**ENVIRONMENTAL BOARD MEETING MINUTES Wednesday, October 15, 2008,**

**a. Name: Wildflower Commons PUD C814-06-0233**

**SUBJECT:** Corrections to ERM's August 22, 2007 memo regarding Critical Environmental Feature setbacks of Wildflower Commons.

**b. Name: Ben White/ IH 35 Bioretention/Extended Detention Pond SP-2008-0227D**

**Map 1: Location Map for Critical Environmental Feature Setbacks  
(Revised - 07-07-2008)**

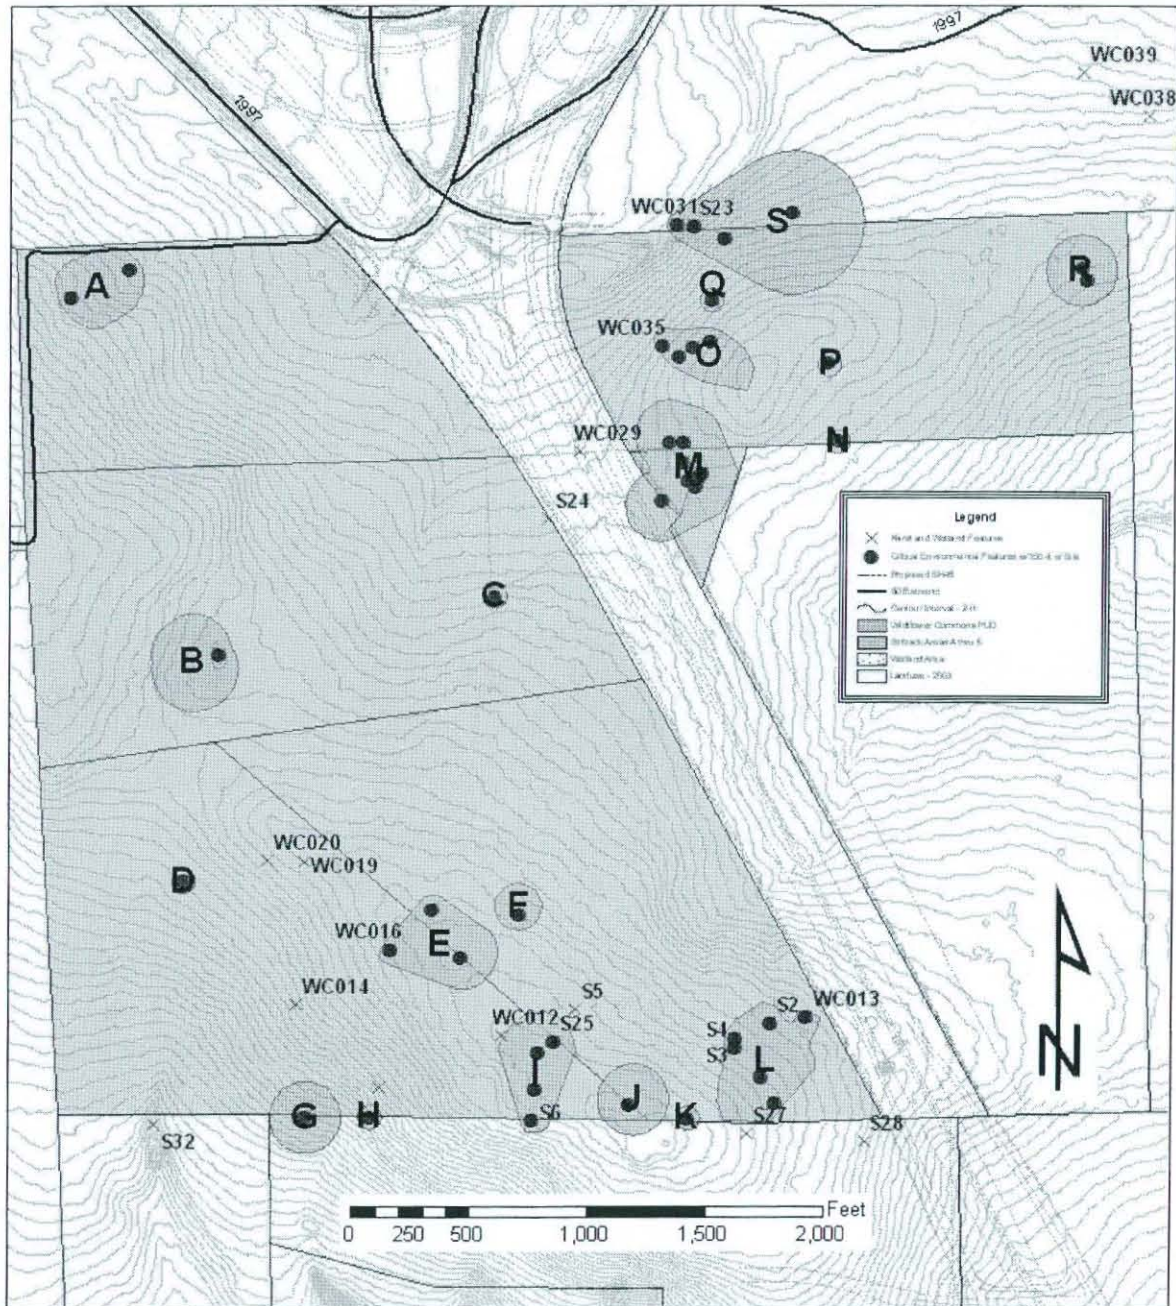
Based the surface drainage patterns, 2-ft topography, the type of feature, the feature's size and the density (or clustering) of features, ERM staff is recommending protecting the critical environmental features with 19 critical environmental feature setback areas (Labeled A thru S). The attached map shows the location of the setback areas. ERM staff is recommending that the CEFs and their associated setback area (or buffers) are documented within the PUD ordinance along with the following Land Development Code (LDC) requirements from Section 25-8-281.

1. No residential lots may include a CEF or be located within 50 feet of a CEF.
2. Setback areas must be established to protect all CEFs. Although the LDC allows a portion of the CEF buffer to be included in a residential lot, I do not recommend that this be allowed. Residential lots should not include any portion of a CEF buffer. Setbacks must comply with the setback area has stated in Table 1 and shown Map 1. ERM is willing to revise setback areas listed in Table 1 and shown on Map 1 during PUD process, if the applicant provides more detail information to ERM staff such as 1-ft topographic survey that better delineates the catchment areas and a hydrogeologic assessment the features that better evaluates it recharge potential.

1. All CEFs must be shown on a topographic map (or maps), and listed in a summary table and included on an exhibit (s) in the PUD ordinance. The table must include the identification of the CEF, the type of CEF, and the recommended setback area. All maps must be must have north arrow and reference scale.

**Map 1: Location Map for Critical Environmental Feature Setbacks  
(Revised - 07-07-2008)**

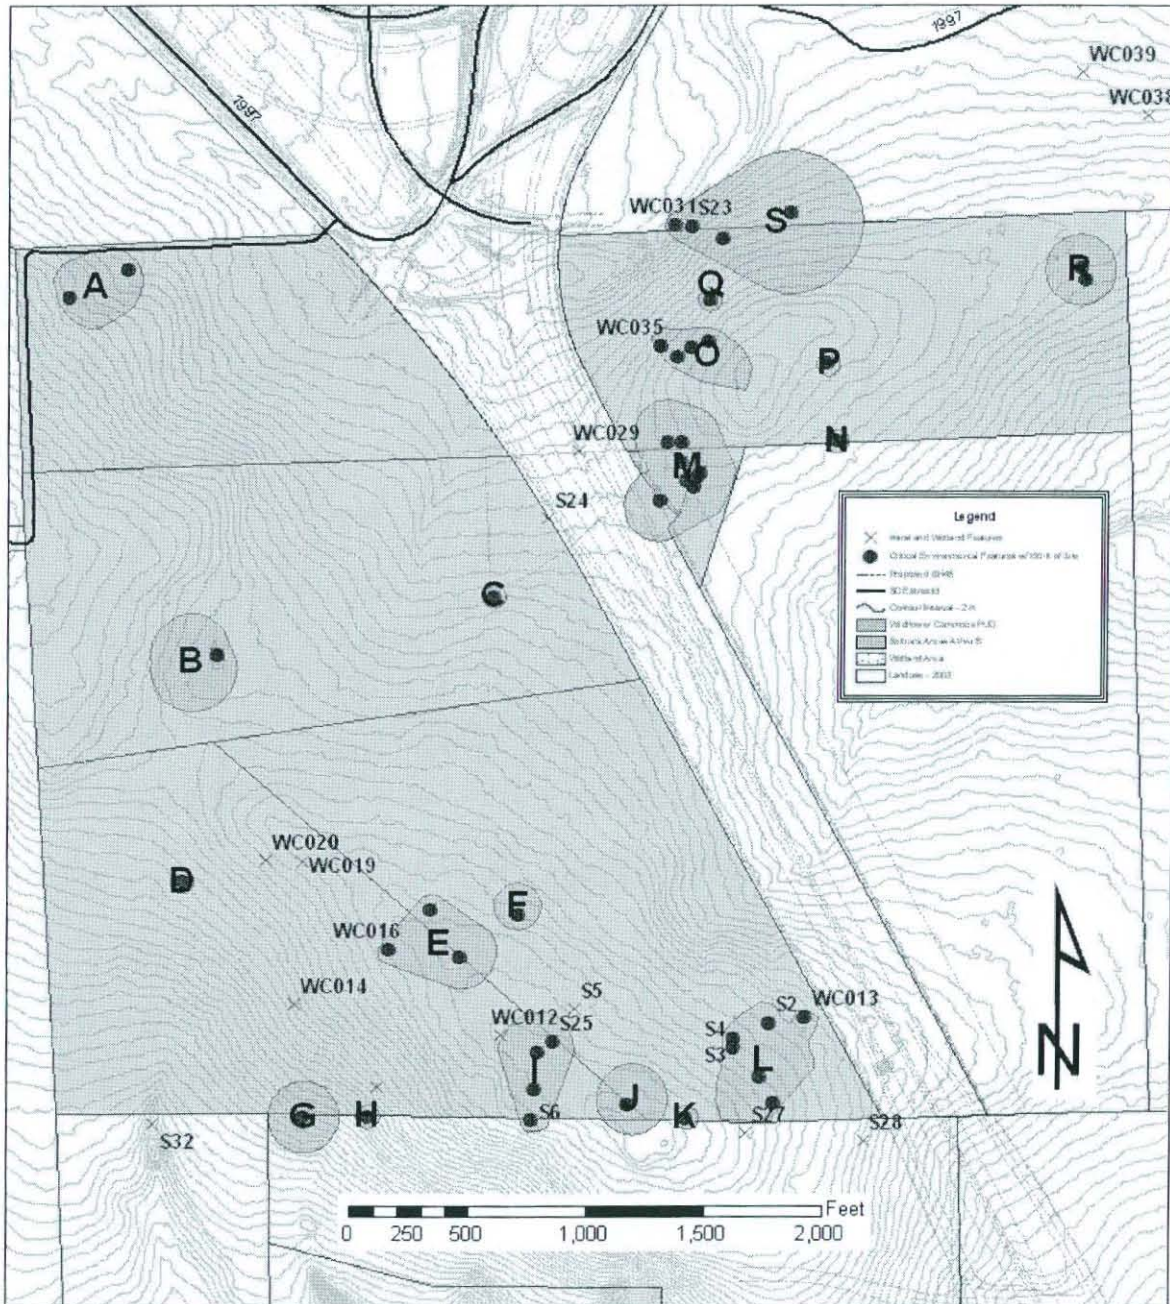
1. No residential lots may include a CEF or be located within 50 feet of a CEF.
2. Setback areas must be established to protect all CEFs. Although the LDC allows a portion of the CEF buffer to be included in a residential lot, I do not recommend that this be allowed. Residential lots should not include any portion of a CEF buffer. Setbacks must comply with the setback area has stated in Table 1 and shown Map 1. ERM is willing to revise setback areas listed in Table 1 and shown on Map 1 during PUD process, if the applicant provides more detail information to ERM staff such as 1-ft topographic survey that better delineates the catchment areas and a hydrogeologic assessment the features that better evaluates it recharge potential.

2. All CEFs and associated CEF buffers are to be shown on all plats, preliminary plans, site plans and construction plans. The PUD ordinance and the plat notes must have a following statement "all activities within the critical environmental feature setback must comply with Section 25-8-281(c)(2) of Austin's Land Development Code. This section states that the natural vegetative cover must be retained to the maximum extent practicable; construction is prohibited; and wastewater disposal or irrigation is prohibited this requirement."

**Exhibits Showing Locations of Removed Impervious Cover**

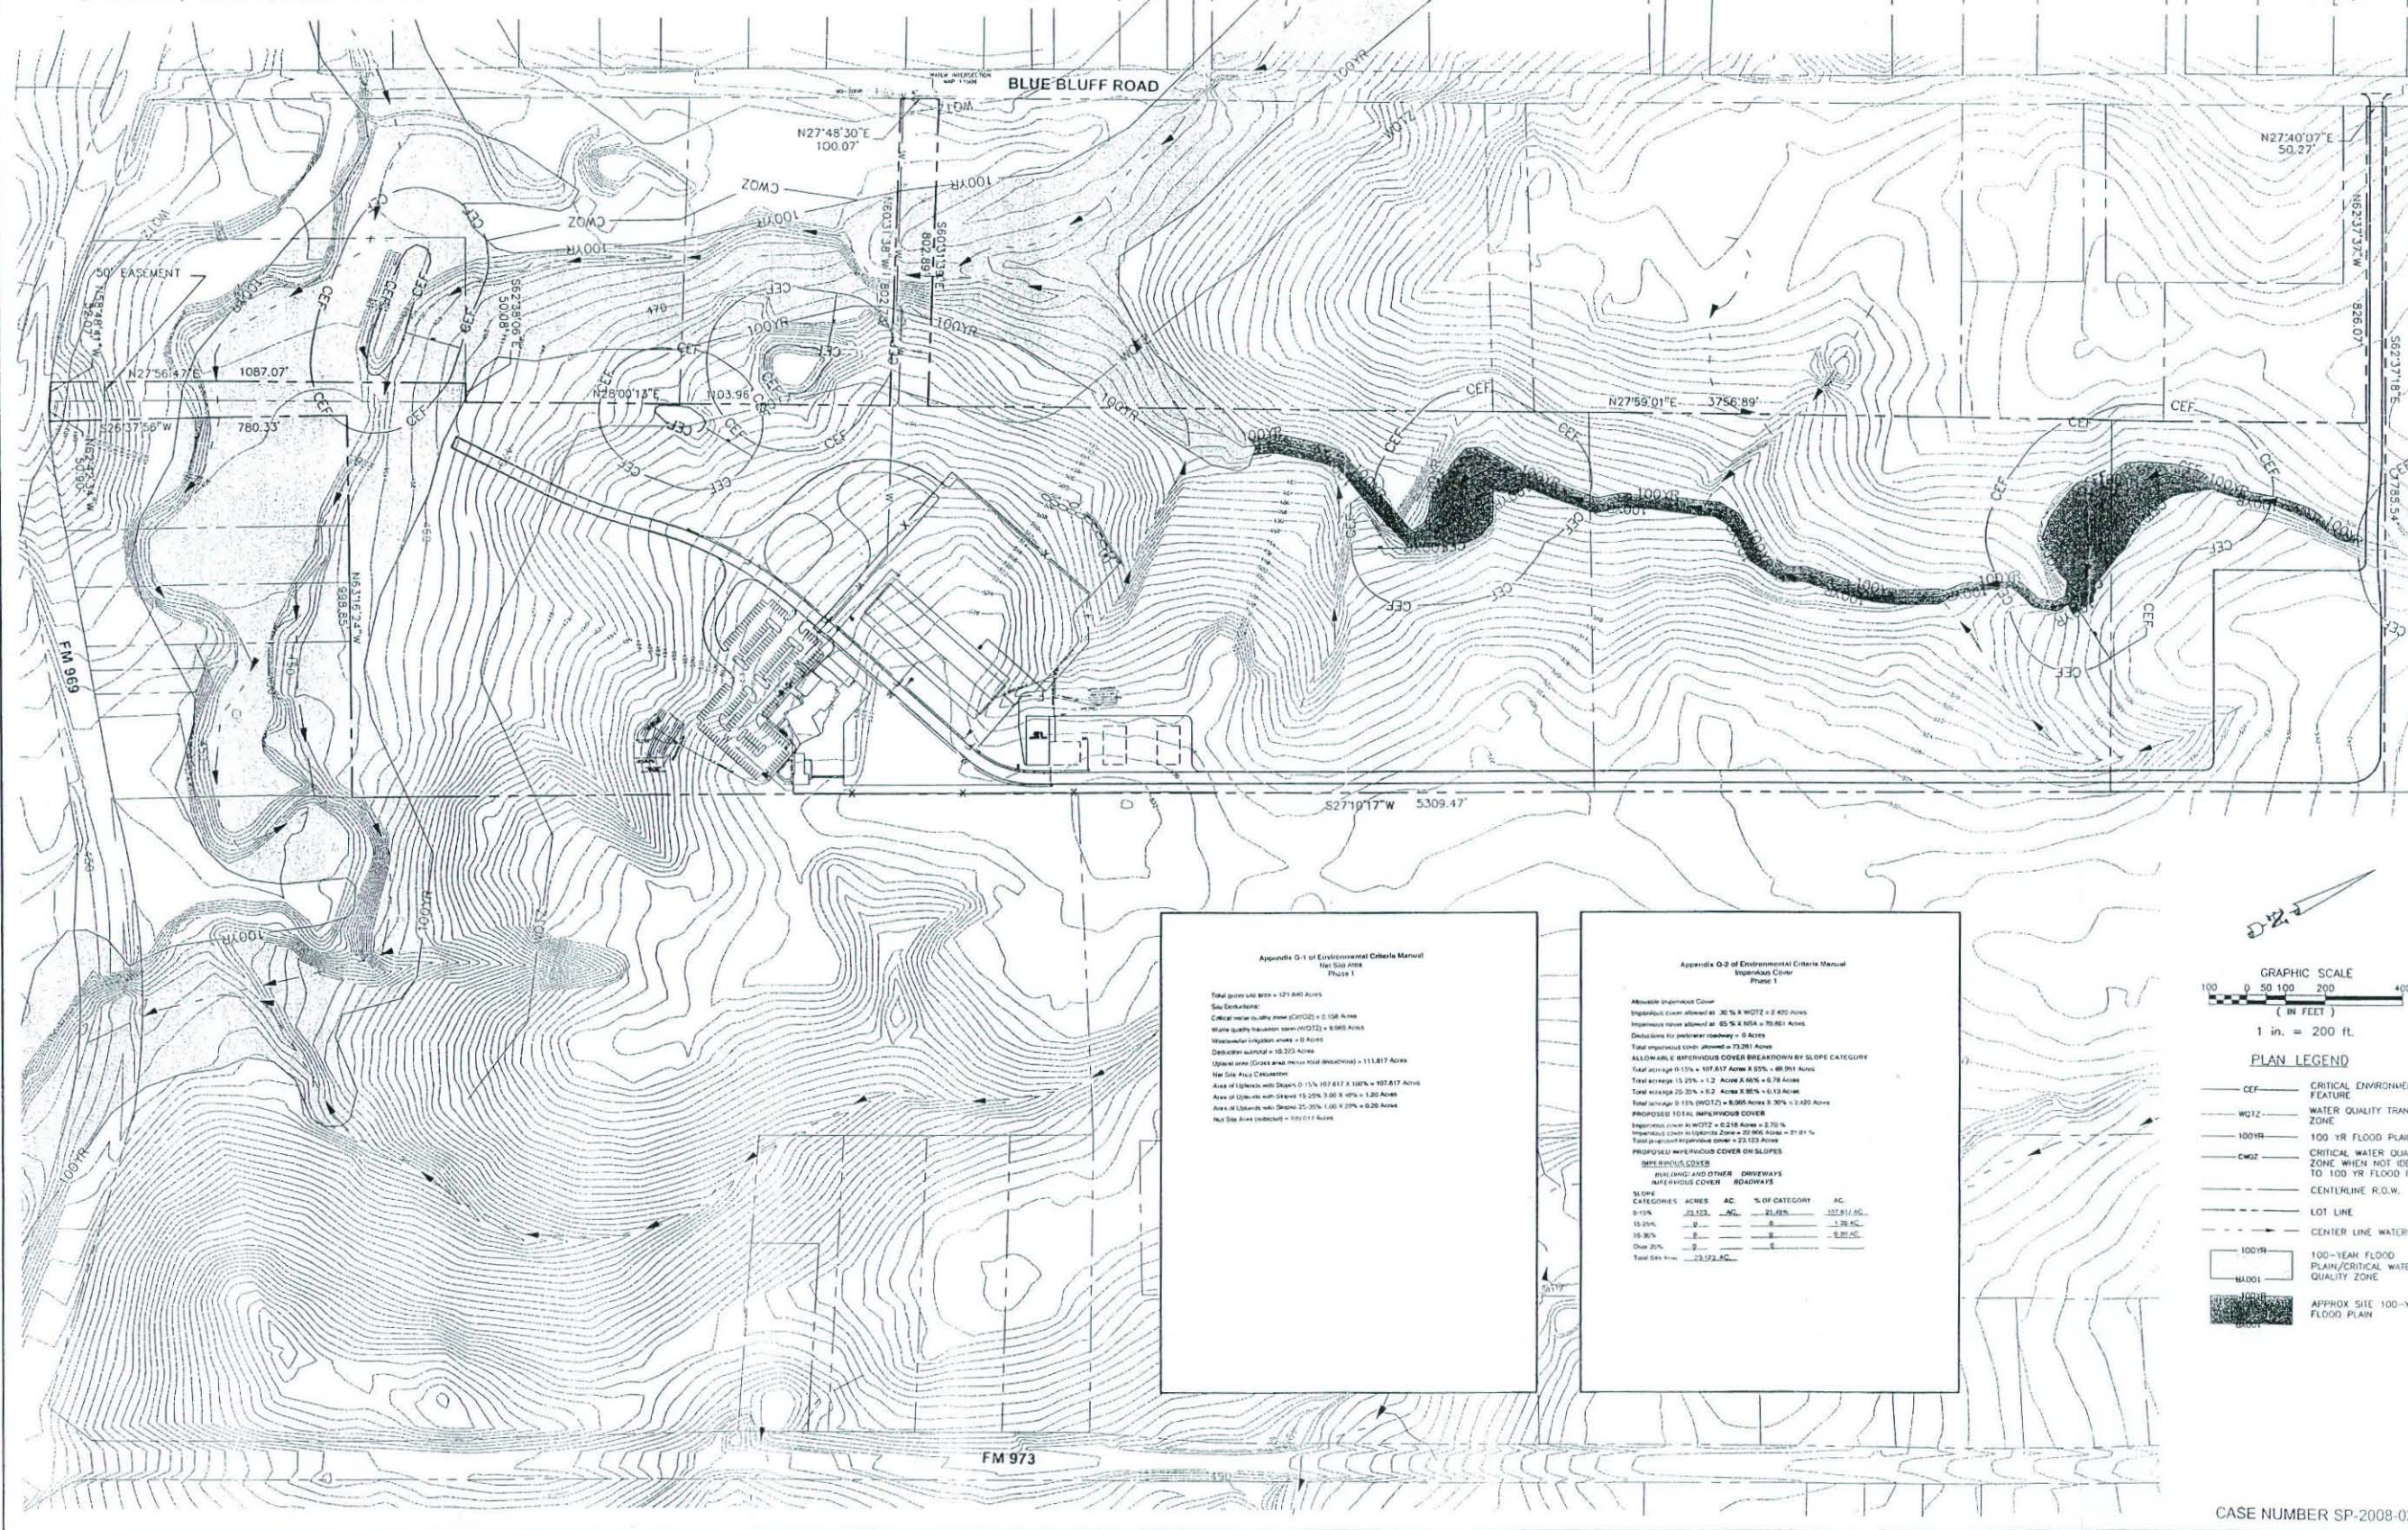
- I want to see the Travis County Project prove Water Quality is being improved. As a result of the Variance being requested.
  - **RESPONSE:** In response to the Board's concerns the County has reduced impervious areas by approx. 66,000 square feet. This places the site at 19.42% impervious cover, below the 20% threshold identified in LDC §25-8-211. In addition, County Staff has worked with City Staff to ensure "temporary BMPs" implemented on-site meet City requirements. The outfall from Pond B has been modified to implement a rock rubble lined channel from the outlet structure, along and then beyond the toe of slope of the pond's containment berm to the natural channel within the site to which it discharges. Additionally, as agreed with City Staff, a catchment channel and sediment trap has been added along the spoil area at the northeast corner of the site for sediment capture from this area at any point in the future.
